**SECTION 4.55(1A) MODIFICATION APPLICATION
85 CARABELLA STREET, KIRIBILLI**

This application has been prepared by Ethos Urban on behalf of Loreto Kirribilli, pursuant to section 4.55(1A) of the *Environmental Planning and Assessment Act 1979* (EP&A Act) to modify Development Consent SSD 16_7919 relating to 85 Carabella Street, Kirribilli address (the site).

Figure 1 Comparison of approved (red) and proposed building outline (ground level)
Source: FJMT

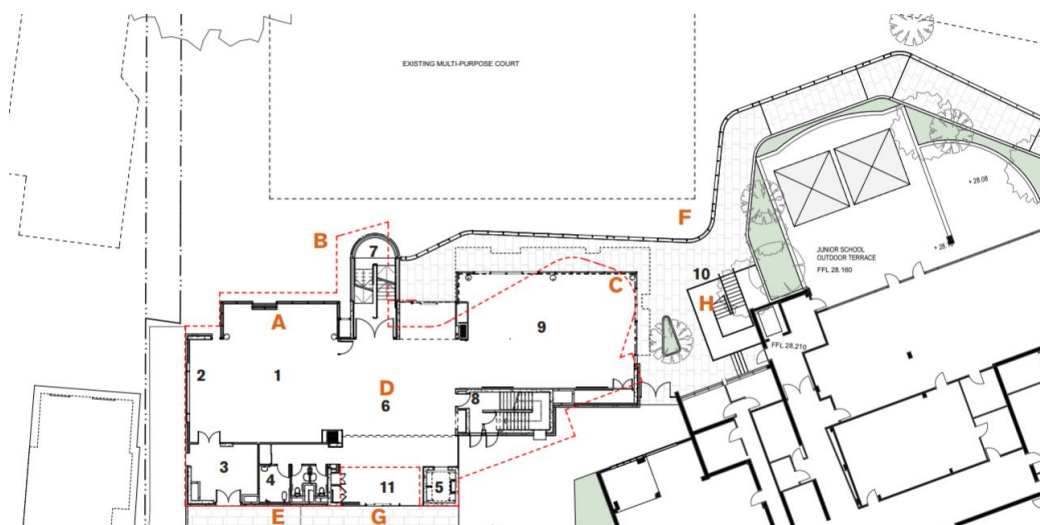
As a result of ongoing design development, the massing and scale of the Innovation Centre has been further considered to reduce the scale of the northern elevation and the northern staircase. The western wing of the new building is aligned with both the Carabella Street and Marian Centre grid. To improve the amenity and the functionality of the learning spaces, the eastern wing has now been realigned from an angled form to a straight orientation to be on the same grid. A comparison between the approved and proposed building layout (at ground level) is shown at **Figure 1**.

These changes have resulted in an overall reduction in the building mass, as well as the extent of excavation required. Further, the building height remains consistent with the RLs approved under Condition B4 of SSD 16_7919, as outlined in **Table 2**. Additionally, in order to resolve the revised orientation of the eastern wing, the location of the southern access stairs has been marginally revised resulting in a minor change to the structures at roof level. An assessment of view impacts is provided at **Section 4.2.2**.

Figure 2 Comparison of approved (red) and proposed walkway (lower ground level 1)

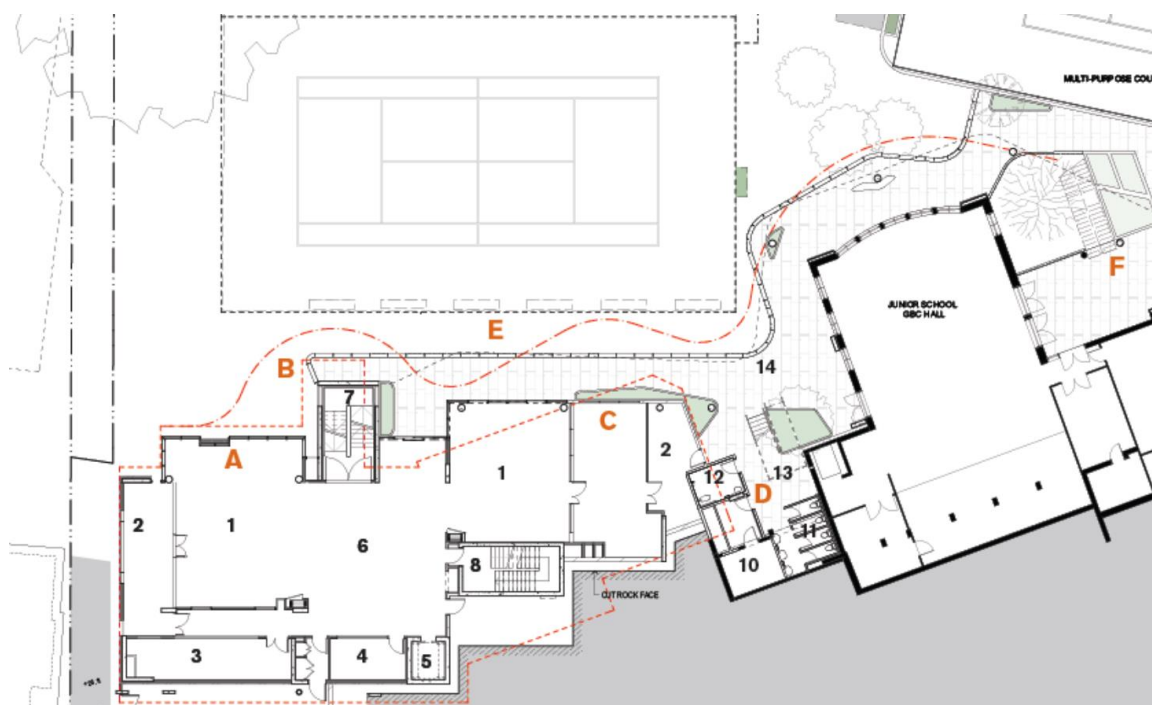
Specifically, the modifications to the external walkway include the relocation of planter boxes away from the perimeter of the space and a change to a more linear design (refer to **Figure 1**). A review of the edge conditions concluded that planter beds located away from the balustrade resulted in a more functional outcome for the following reasons:

- Reduced fall risks from planter beds if used as a seat or traversed by students, staff or visitors.
- Operational issues in carrying out maintenance using safety lines in areas with high foot traffic.
- Greater opportunities for larger volumes of soil and greater varieties of planting.
- Re-positioned planter beds may present sitting opportunities which previously would not be achievable due to fall risks.

Table 3 Eastern Visual Impact (approved building outlined in red)

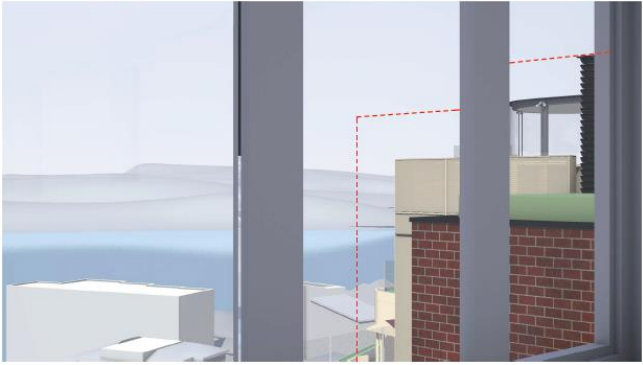
The reorientation of the building form and associated changes to the southern access stair has resulted in minor changes to the structures at roof level, and alterations to the views from east facing apartments in the adjacent building at 111 Carabella Street.

Table 3 provides a comparison of the approved and proposed views from apartment 9/111 Carabella Street. The views show that there has been a minor reduction in footprint of the lift, southern stair and plant enclosure. However, due to the reorientation of the eastern wing, their location is slightly altered. As a result, there are minor changes to views, and there is an overall gain in access to sky views when compared to the approved development.

It is noted that the lift overrun and stair continue to be within the maximum 12m height limit which applies to this part of the site under North Sydney LEP 2013. The use of glass for the lift and stair overrun will ensure a more transparent built form and less obstruction of sky views from the neighbouring property.
